E8362B-06**S E R V I C E N O T E**Supersedes:
NONE**E8362B PNA Series RF Network Analyzers****Serial Numbers: MY00000000 - MY43021625****Add-on mechanical components to enhance instrument reliability****To Be Performed By: Agilent-Qualified Personnel or Customer with specific product repair knowledge – requires instrument disassembly and component replacement.****Parts Required:**

Situation:

Further design review has suggested the addition of a clamping mechanism to ensure that the 8121-0118 ribbon cable can not vibrate loose from the Test Set Motherboard connector during extreme handling.

McMaster Carr item 6959A18 (T-10 torx size L-key)

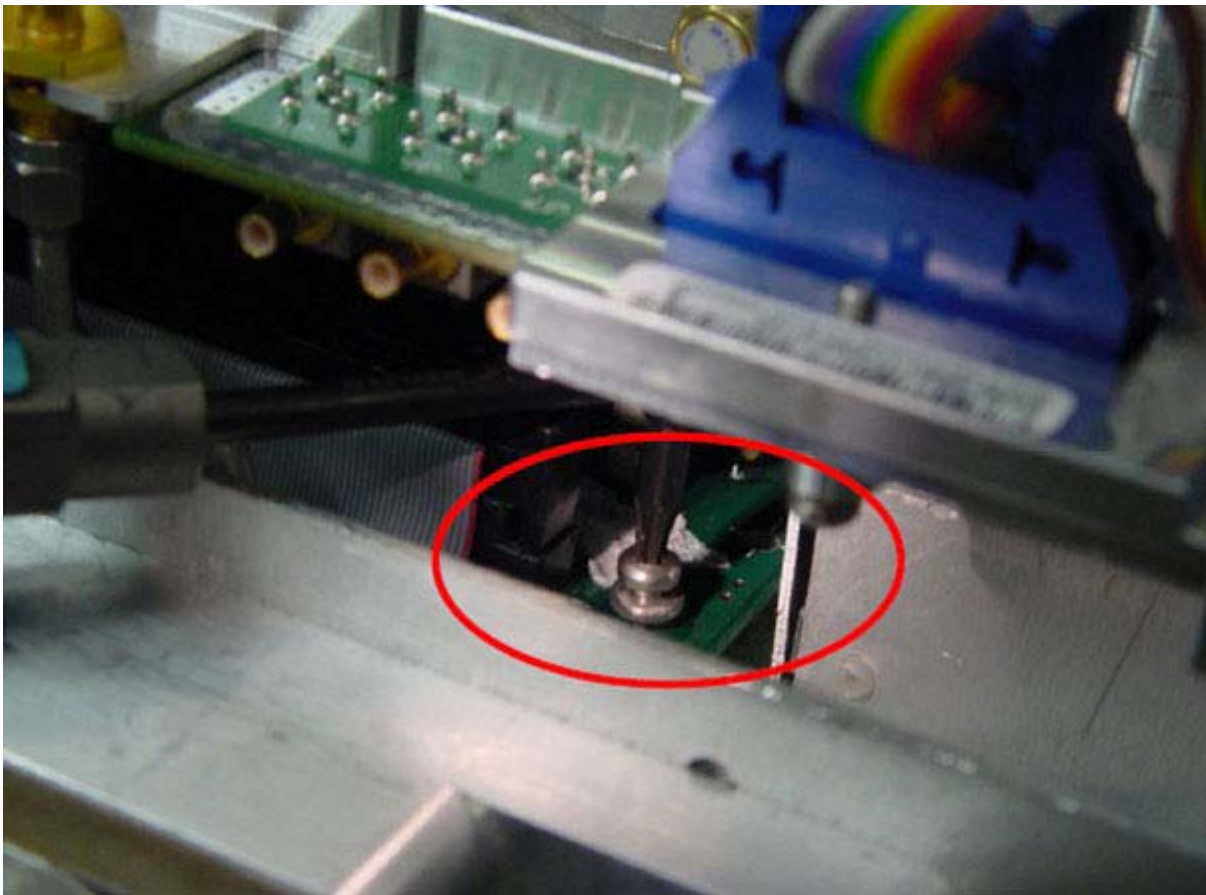
- b. Remove the open end head by loosening set screw. It will be replaced with L-Key shown below.

- c. Secure and orient the L-Key to the breakaway handle

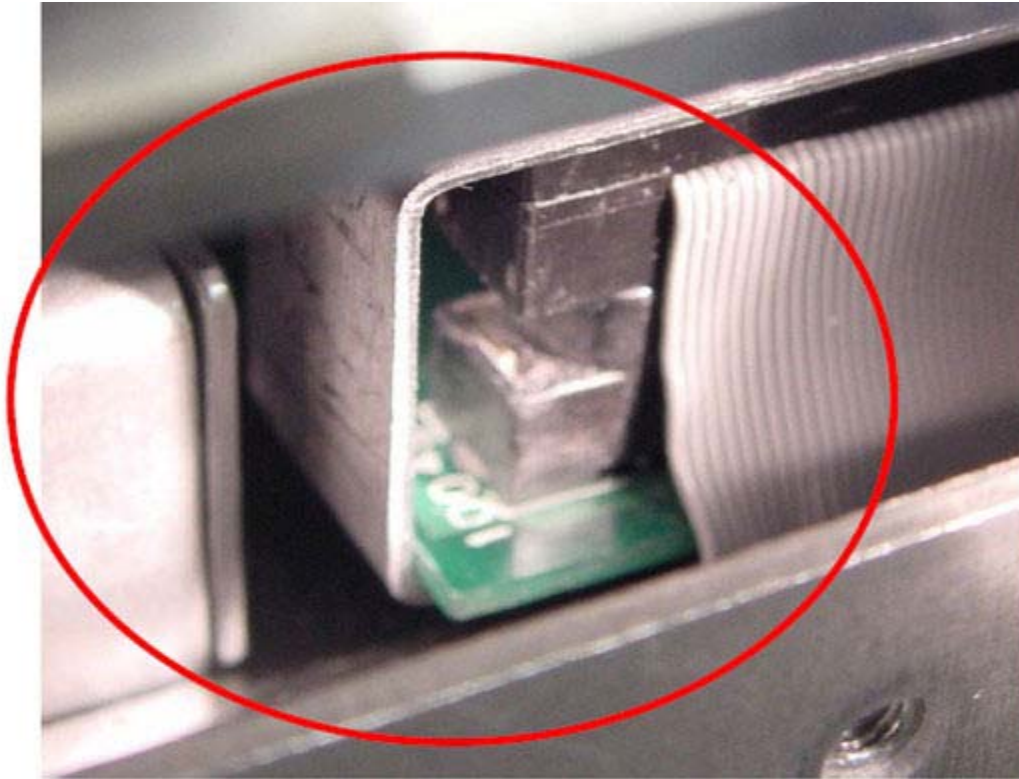
- b. Insert Ribbon Cable Clamp under Source Assembly as shown.

- c. Position the clamp over the Ribbon Connector. Use needle nose pliers if necessary to slide the clamp into place. Ensure that the edge of the clamp is parallel to the connector and not skewed.

NOTE: Ensure that the Clamp Lip is secured **BELOW** the edge of the System Motherboard

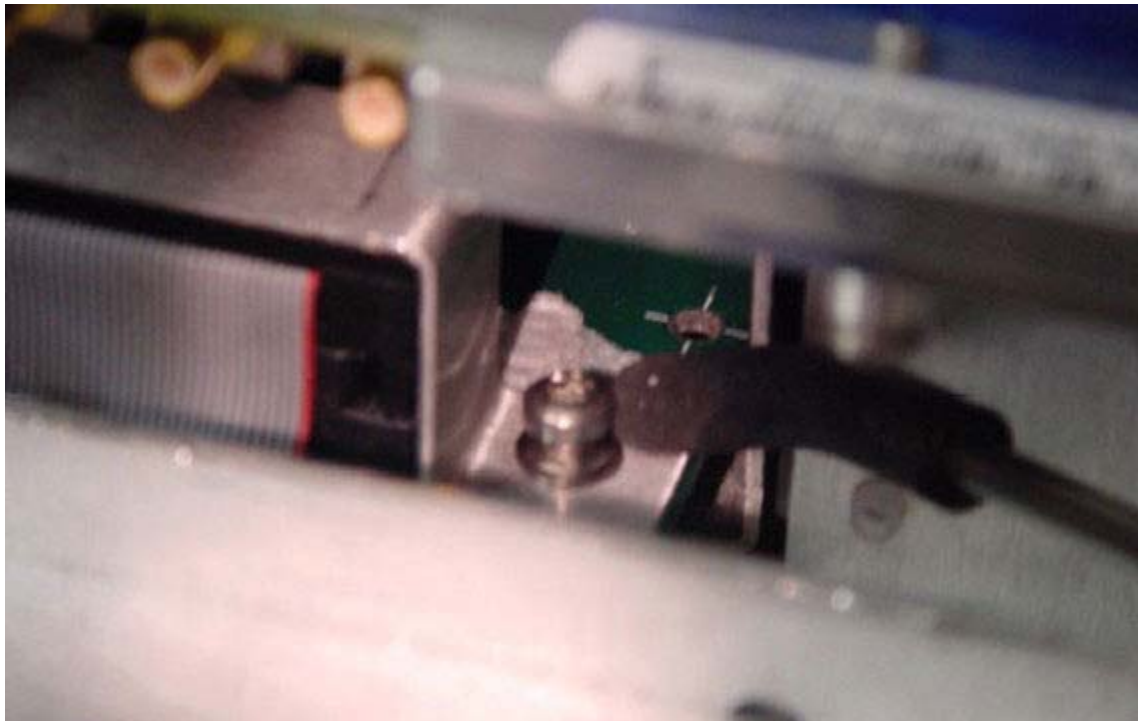
- d. Using tweezers, install a new 0515-0374 screw through the hole in the bracket.

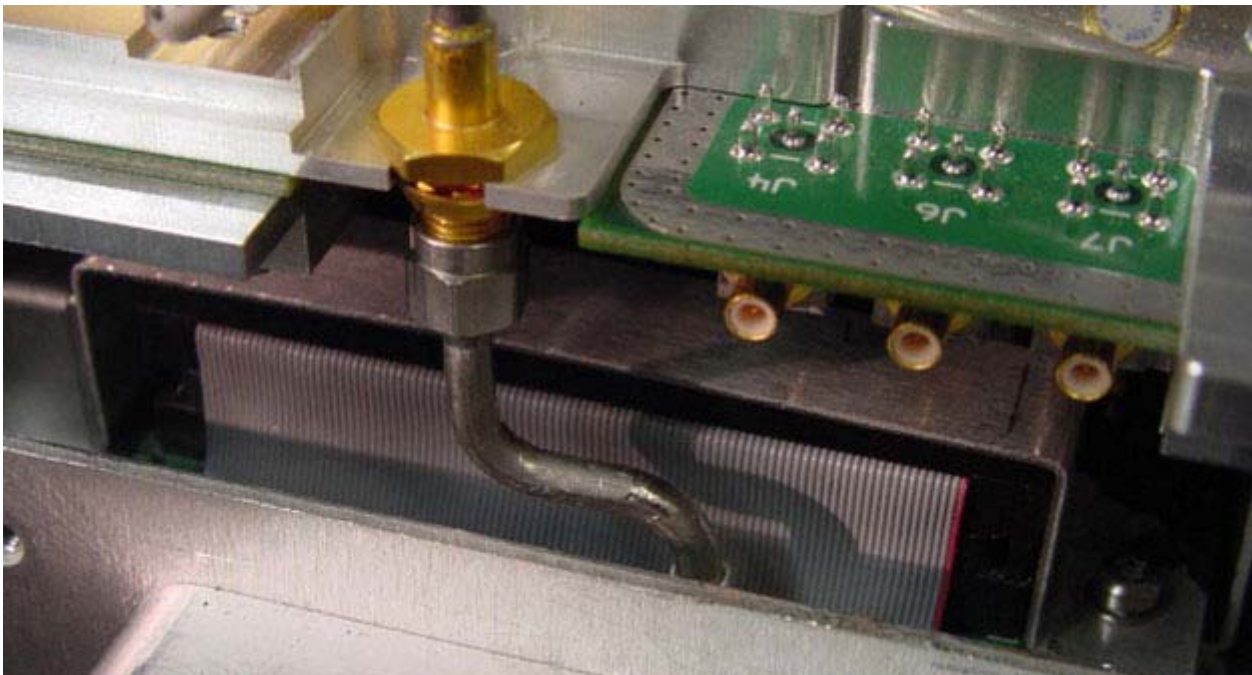
- g. This image shows the final position of the secured clamp.

Figure 2a

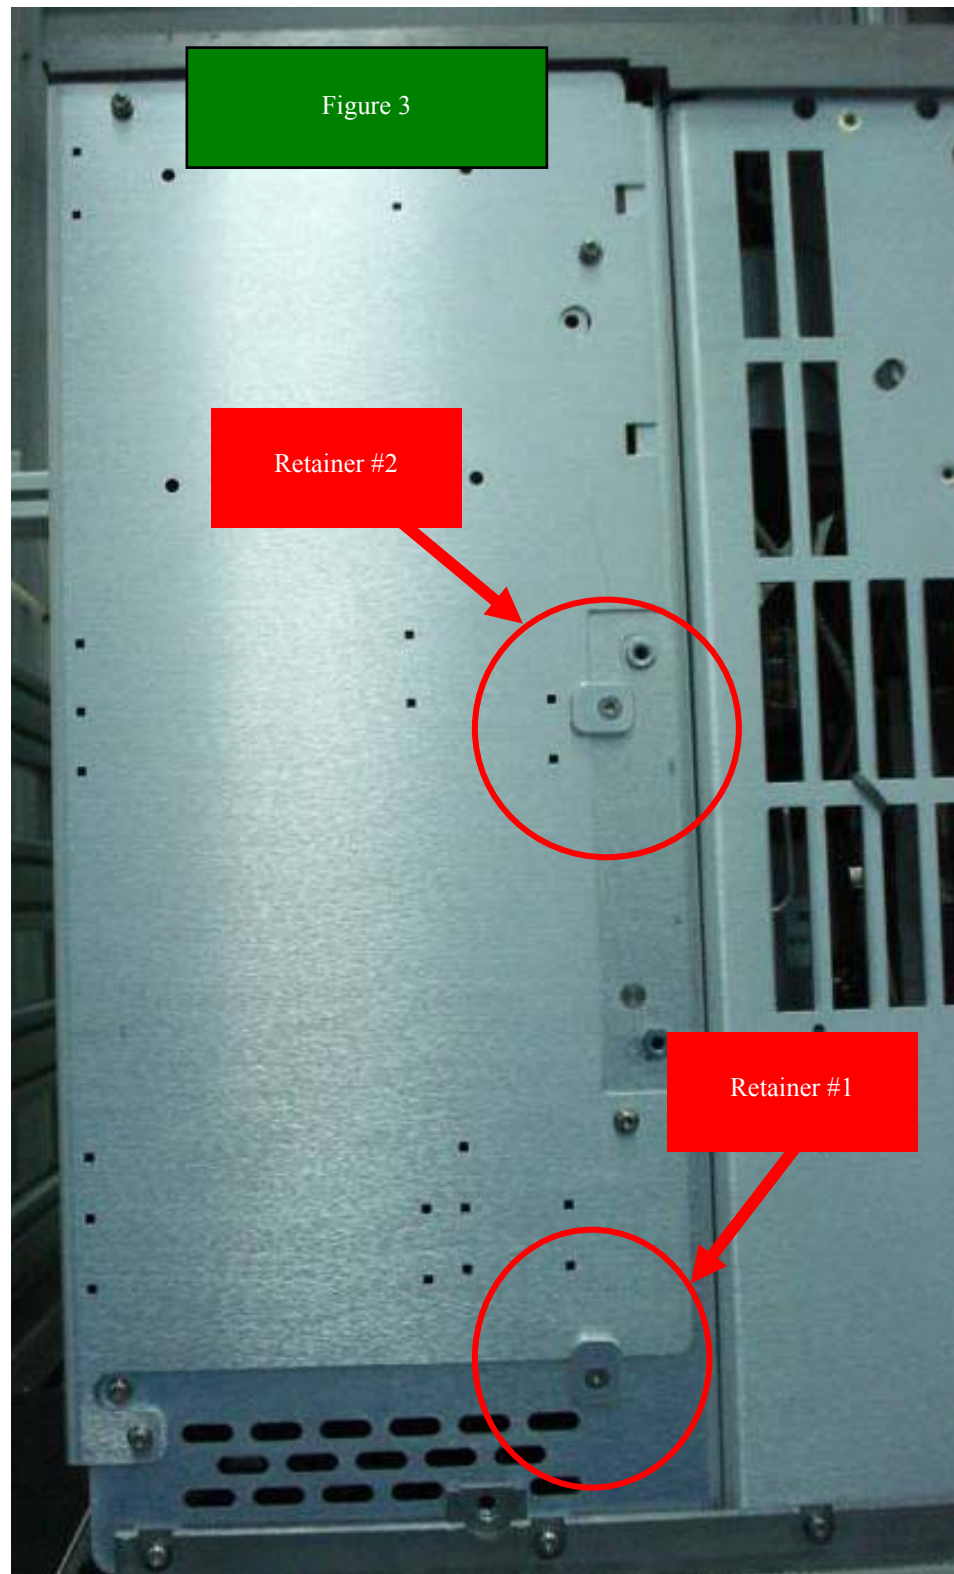
The Clip Retainer (E8361-20067) to be secured with Flat Head screw (0515-1644) in 2 places at 9 lb-in. This Retainer Clip may naturally rotate a bit when being secured, which is acceptable. Note that the existing screw needs to be removed and discarded prior installing Retainer Clip #1 (shown below in Figure 2a, 2b, and 3).
